From: Rich Lucia
Sent: Wednesday, March 25, 2026 3:19 PM
To: Megan Elwell; Amy Silva; Cstaff
Cc: Tim Smith
Subject: RE: 2026-01-003 - Newport Cliff Walk

RESPONSE TO COMMENTS

Re: Newport Cliff Walk Repairs

PHOTO 3: BEDROCK UNDERCUTTING AT THE TOE OF THE EXTANT GRANITE BLOCK WALL - LOOKING SOUTH

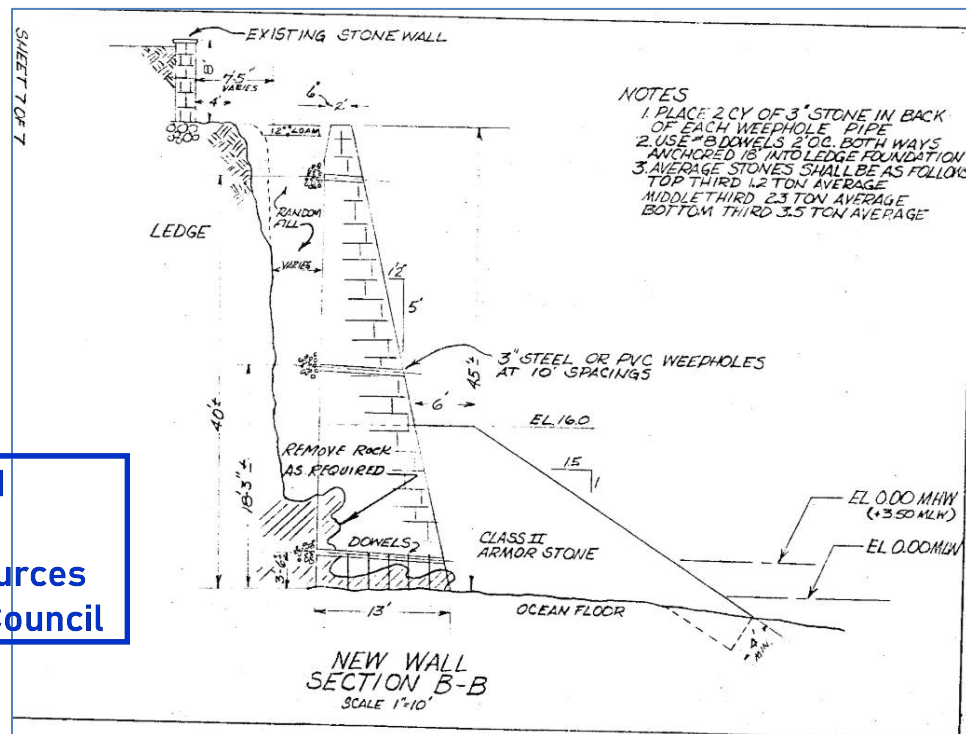
HPHC Comment - Section 2: When was the extant granite block wall installed? If there is not an additional armor layer present, one might presume that the wall was designed to not need one. Are plans from the wall construction project available to indicate whether or not there was an armor layer seaward of the wall which was either not installed or has been displaced? If there was not such a layer, what has led to the decision to install one?

GZA Response: *The extant granite block wall is understood to have been installed circa 1976, based on CRMC Assent 75-9-13, which depicts both the stone wall and a revetment seaward of it. While the original plans indicate the intended presence of a protective stone layer, existing-condition surveys show that no functional armor layer remains in place today. Field observations instead document undermining at the wall's interface with the bedrock surface, indicating that any previously placed armor was either never installed as designed or has since been displaced by decades of wave action.*

- *Structural condition of the wall — Survey data show voids and undercutting at the bedrock contact, demonstrating that the wall is currently exposed to direct wave attack. This condition is inconsistent with long-term stability and suggests that the wall is no longer receiving the toe protection originally envisioned.*
- *Visual evidence of active erosion — Photographs of the site clearly show eroded and scalloped bedrock outcrops seaward of the wall. This pattern of bedrock wear is characteristic of repeated high-energy wave impact and confirms that the shoreline is actively retreating at the toe. Continued erosion of this surface will progressively remove support from the base of the granite wall, eventually leading to settlement, rotation, or localized failure.*

Given these conditions, the decision to install a new riprap armor layer is driven by the need to re-establish the level of protection the wall requires to remain stable. The proposed riprap revetment will shield the exposed bedrock and wall toe from further erosion, dissipate wave energy before it reaches the wall, and prevent the progressive undermining that is already observable in the field.

REVISIONS			PAVED DITCH		R.I. STANDARD 8.2.0
NO.	BY	DATE			
1	AMM	Jan 25			
			<i>Robert Rocchio</i>	<i>Lori A. Fisette</i>	JUNE 15, 1998
			Chief Engineer for Infrastructure TRANSPORTATION	Director, Division of Project Management TRANSPORTATION	ISSUE DATE

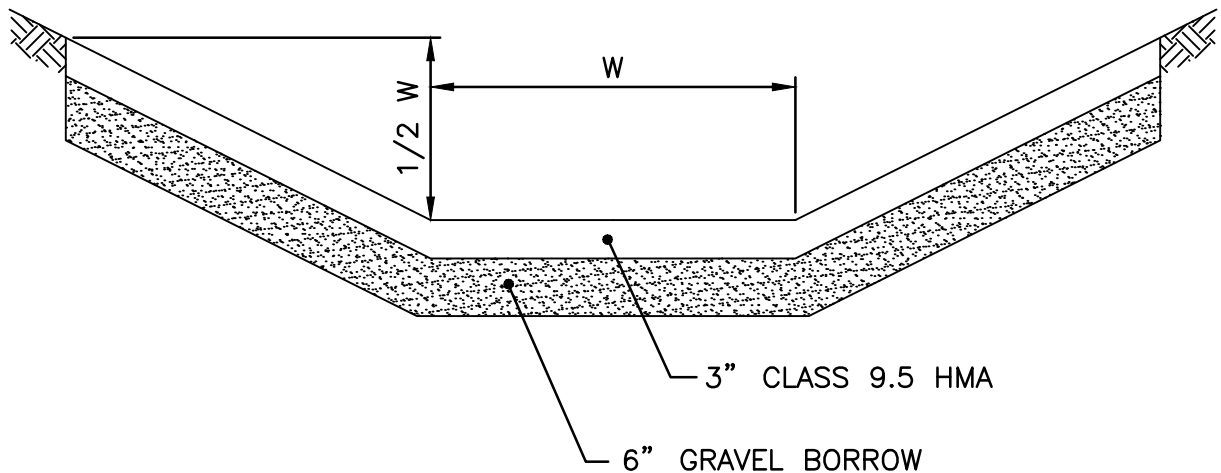
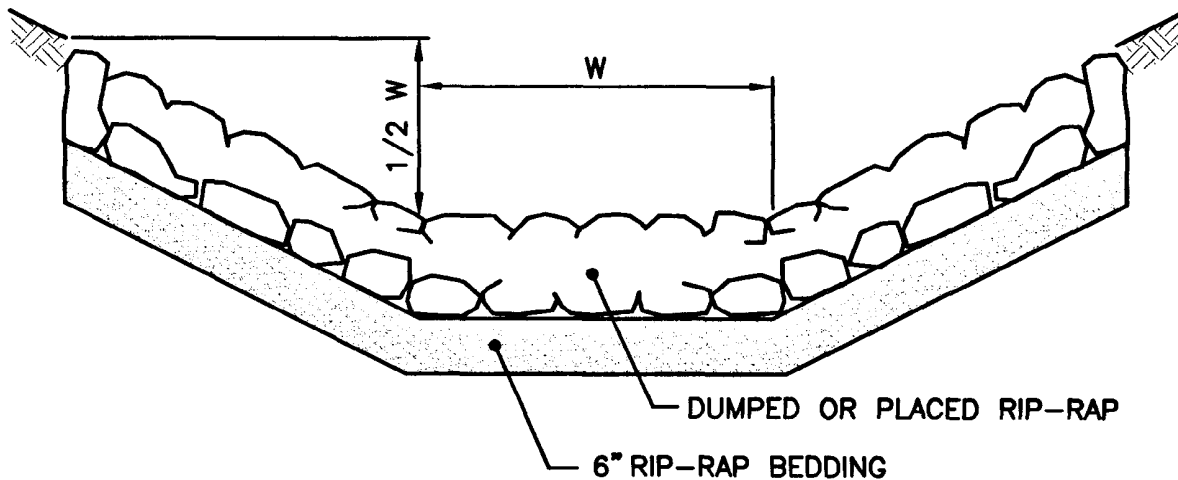
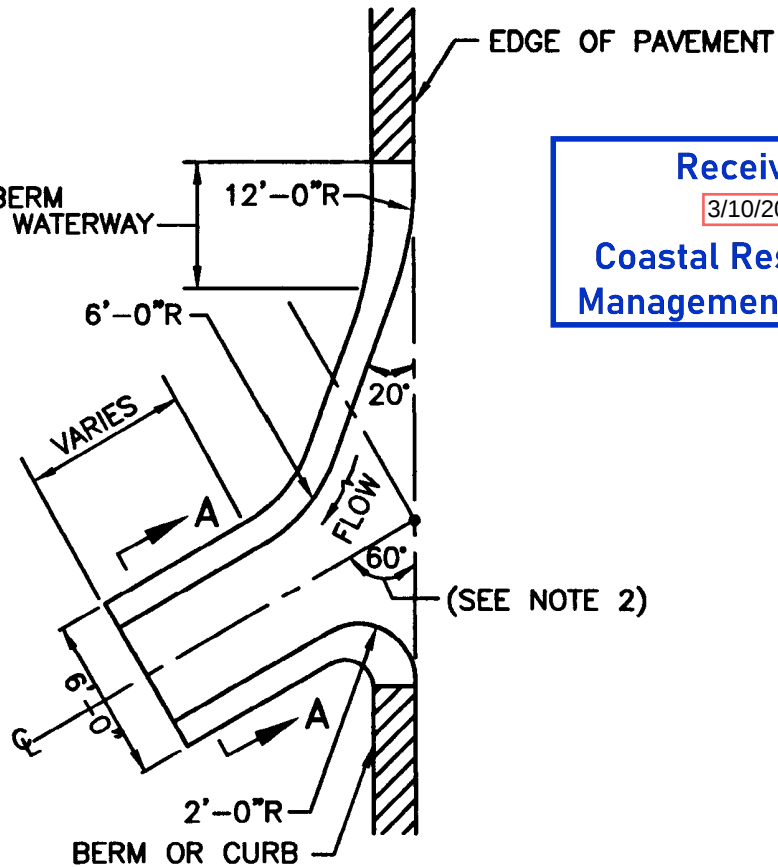
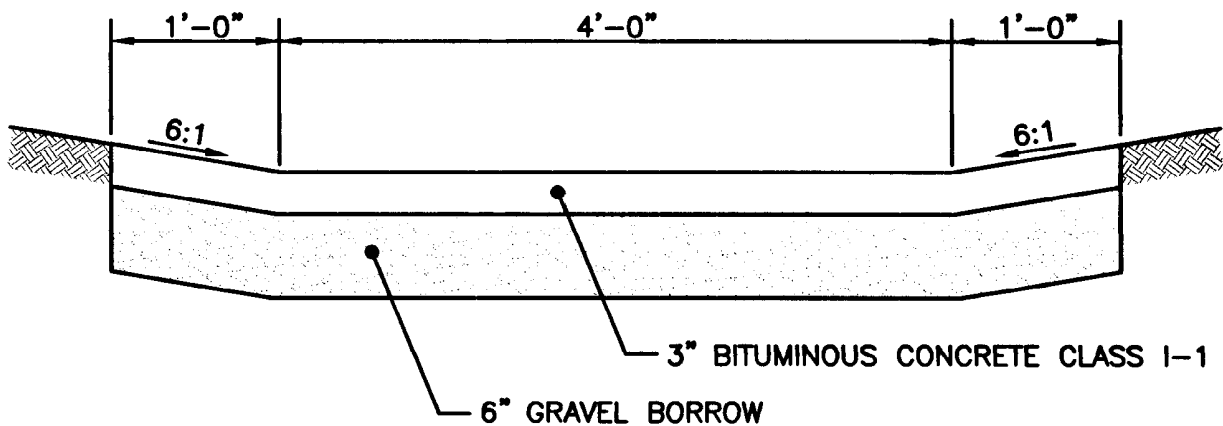
HPHC Comment - Section 3: Please provide details for the proposed paved gutters shown on Drawing 19, such as the paving material, edge treatments, and side-to-side section

GZA Response: *It is the design intent for gutters / paved waterways to be installed to better convey surface water from the walkway to the cliff face, bypassing the erodible sediment layer. They may be comprised of bituminous asphalt, concrete, or rip-rap revetment. The gutter / waterway will be similar to (but smaller than) RI Standard Detail 8.2.0, 8.3.0, or 8.4.0.*

GZA will revise the drawings to include a better detail and include the system within the Contract Specifications and will periodically direct water from the walkway to the face of the cliff to reduce erosion of sediments.
